UNITED STATES PATENT AND TRADEMARK OFFICE

Office Action Summary

10/707,860

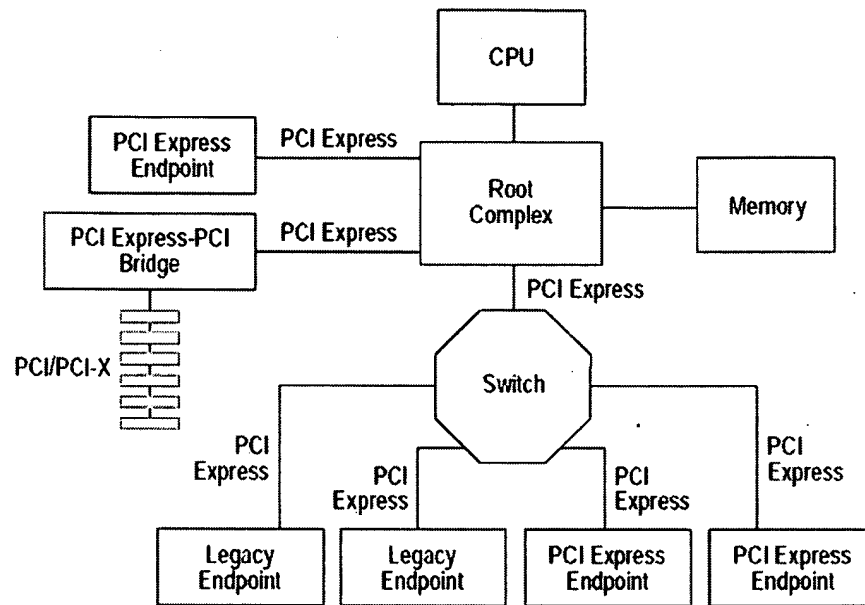
With regard to claim 5, PCI Express discloses an extendable computer system comprising: a motherboard for maintaining the functionality of the computer system (it is clearly inherent that computer system based on PCI Express must be laid out on a motherboard or main board. As shown below at Figs. 1-2, on page 31, of the PCI Express, the PCI Express based computer system including a CPU, buses, and peripheral components must be placed on a motherboard or main board)

, the motherboard comprising: a system chipset for supporting a specification of a first interface (the Root Complex Port Chip Set in PCI Express manages the PCI Express fabric, and supports PCI Express interface); at least one first standard communication interface slot electrically connected to the system chipset for electrically connecting at least one peripheral device to the computer system (it is clear from the PCI Express, Figure 1-2 above that each PCI Express Endpoint comprises a PCI Express slot for a plug-in PCI Express card or peripheral device); and a first extending port electrically connected to the system chipset for extending functionality of the motherboard (it is clear that the PCI Express bus of the motherboard connecting the Root Complex chipset to the PCI Express-PCI/PCI-X bridge has a first port for providing connection to second port of PCI Express-PCI/PCI-X bridge for the motherboard to extend its functionality to the PCI/PCI-X legacy peripherals); and an extended board capable of electrically connecting to the motherboard for extending the functionality of the

computer system (PCI Express-PCI/PCI-X bridge as shown above in Fig. 1-2, i.e. the Intel 41210 PCI Express-PCI/X bridge, cited below, is capable of electrically connecting to the motherboard for extending the functionality to the legacy PCI-X peripherals), the extended board comprising: a second extending port capable of electrically connecting to the first extending port for electrically connecting the extended board to the system chipset of the motherboard (it is clear that the PCI Express bus of the motherboard connecting the Root Complex chipset to the PCI Express-PCI/PCI-X bridge has a first port for providing connection to second port of PCI Express-PCI/PCI-X bridge for the motherboard to extend its functionality to the PCI/PCI-X legacy peripherals), wherein at least one end of the second extending port is in accordance with the specification of the first interface (it is clear from the PCI Express, Fig. 1-2, one end of the PCI Express-PCI/PCI-X bridge supports PCI Express interface); a second interface converter electrically connected to the at least one end of the second extending port for converting the first interface into a second interface (it is clear that the PCI-Express-PCI/PCI-X bridge, as its name implies, provides an interface converter connected to one end of the second port for converting the PCI Express interface into a PCI-X interface); and at least one second standard communication interface slot electrically connected to the second interface converter for electrically connecting at least one peripheral device to the computer system (it is clear from the PCI Express, Figure 1-2 above that each PCI-X comprises a PCI-X slot for a plug-in PCI-X card or peripheral device), wherein the atleast one second standard communication interface slot is in accordance with the specification of the second interface (the PCI-X slot for a plug-in PCI card must be in full

With regard to claim 11, it is clear from the PCI Express, Fig. 1-2, that the Root Complex is in the North Bridge chipset connected the CPU. Note that the Root Complex chipset can be in either the North Bridge chipset or a South Bridge chipset (see PCI Express: Interconnect of the Future from Anandtech, cited below).

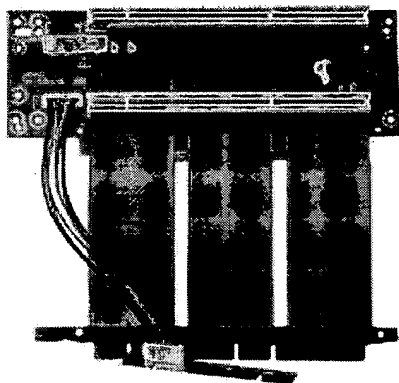
However, the use of a matched gold finger consisting of a gold finger slot and gold finger for providing a connection between the motherboard and the extended board, particular in riser card/board, is old and well-known as evidenced from Garreau (6,769,035) or Rackmountmart.com. Garreau discloses the use of gold finger 30 (Fig. 1A) mated with gold finger slot (Fig. 2) for providing connection between a motherboard and an extended board. Rackmontmart.com also discloses the use of PCI Express gold finger mated with gold finger slot on a motherboard (motherboard slot-6 (PCI-e X16), as shown below:

Note that with the matched gold finger consisting of a gold finger and a gold finger slot provided by either Garreau or Rackmountmart, extended board and the motherboard are aligned in the same plane through the connection of the extending ports, particularly with the use of a riser card/board.
